Re: **Dunes Motel**
Site Plan Comments - First Submission
2052 County Road 18

Thank you for providing a third submission for Site Plan Control Application for the Dunes Motel. The proposal consists of a thirteen unit motel inclusive of a guest suite above the detached lobby building.

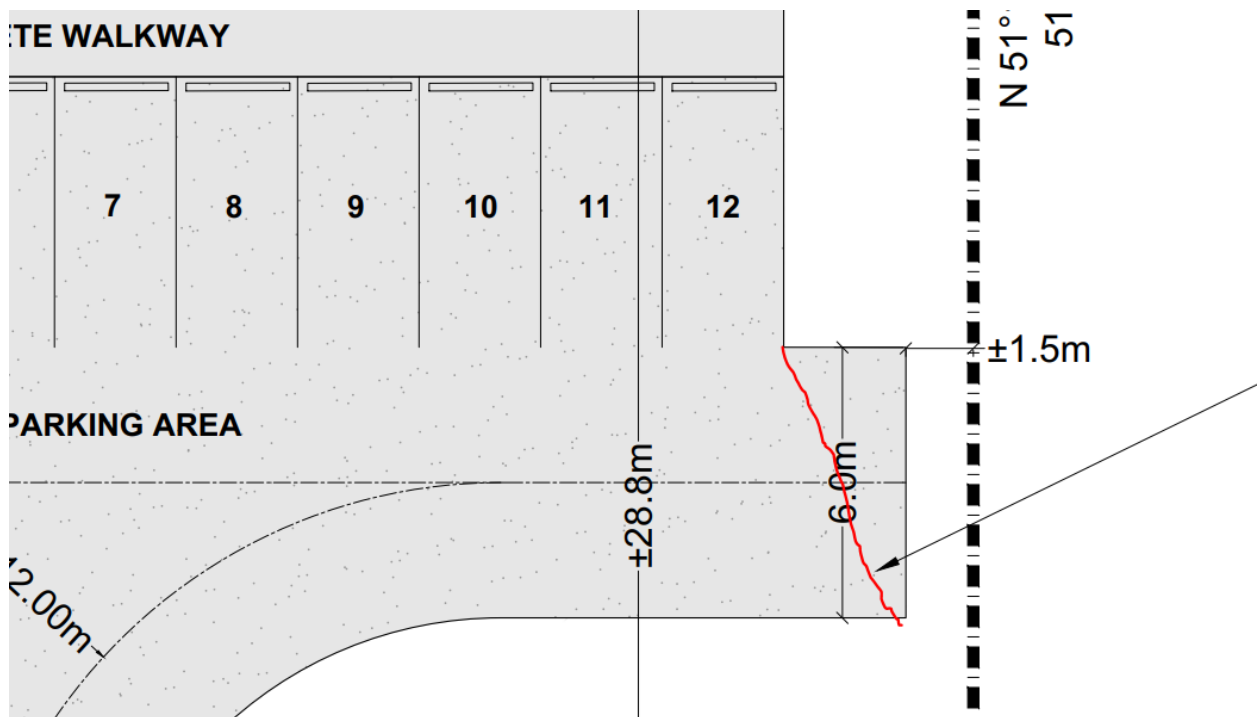
1. Parking spaces 13-15 should be relocated as shown below. The spaces can be accommodated within the existing hardscaped
2. One loading space is required under Section 5.2 (1) of the Zoning By-law. Please identify a location for the loading space. We suggest that the space be provided where spaces 13-15 are identified on the existing site plan.

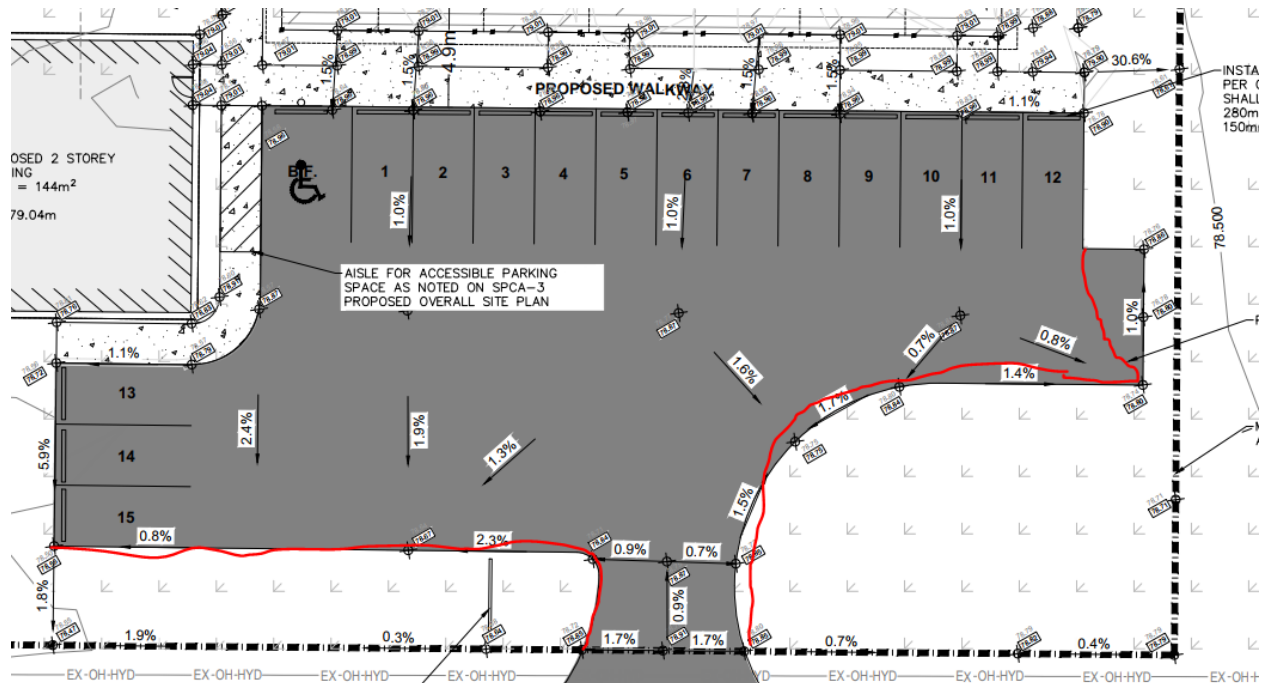
9. Please provide curbing along the boundary for the parking area and entrance, as shown below, to delineate this hardscaping from landscaped open space. We suggest that curbing be provided as per OPSD 600.110.
